Access Compliance Report

Public Rights-of-Way

(Curb Ramps)

Intersection ID: 12925	Main Street: S_CHURCH_ST	Cross Street: W_CARSON_BV	Location: NW
ADA ID: 29F6AD618094	Ramp Type: Perp	Initial Pass/Fail: Fail	Overall Compliance: No
		Severity Score: 25

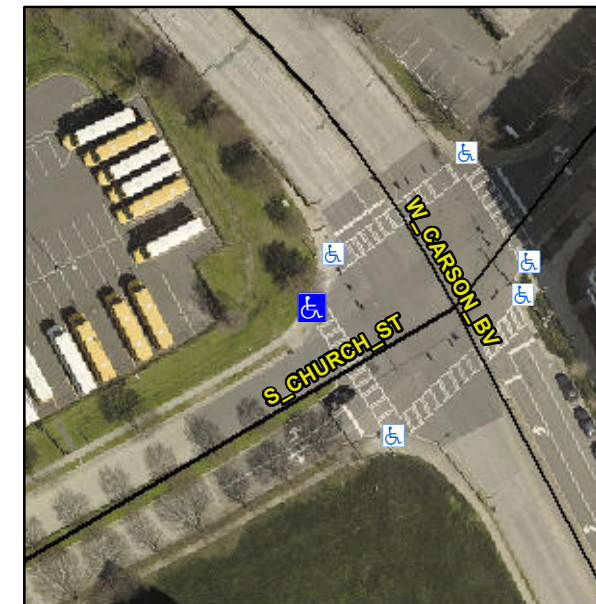
R304.5.3

Compliance	Description	Data	Compliance	Description	Data
N/A	Ramp Length (in)	95.0	Yes	Ramp Slope (%)	8.3
Yes	Ramp Width (in)	48.0	No	Ramp XSlope (%)	8.4
N/A	Flare Type LT	N/A	N/A	Flare Type RT	N/A
N/A	Flare Slope LT (%)	N/A	N/A	Flare Slope RT (%)	N/A
N/A	Flare Traversable LT?	N/A	N/A	Flare Traversable RT?	N/A
N/A	Landing Length (in)	N/A	N/A	DWS Provided?	N/A
N/A	Landing Width (in)	N/A	N/A	DWS Contrast?	N/A
N/A	Landing Slope (%)	N/A	N/A	DWS Length (in)	N/A
N/A	Landing X Slope (%)	N/A	N/A	DWS Full Width?	N/A
N/A	Landing Curb? (Y/N)	N/A	N/A	DWS Offset (in)	N/A
N/A	Shared Landing?	N/A			
N/A	Gutter Ponding?	N/A	N/A	Gutter Slope (%)	N/A
N/A	Gutter Lip Ht (in)	N/A	N/A	Gutter X Slope (%)	N/A
N/A	Painted X Walk1?	Yes	N/A	Painted X Walk2?	N/A
	X Walk 1 Direction	To SE		X Walk 2 Direction	N/A
N/A	X Walk 1 Width (in)	108.0	N/A	X Walk 2 Width (in)	N/A
	X Walk 1 Slope (%)	4.0		X Walk 2 Slope (%)	N/A
	X Walk 1 X Slope (%)	2.2		X Walk 2 X Slope (%)	N/A

Remove & Replace Entire Ramp.
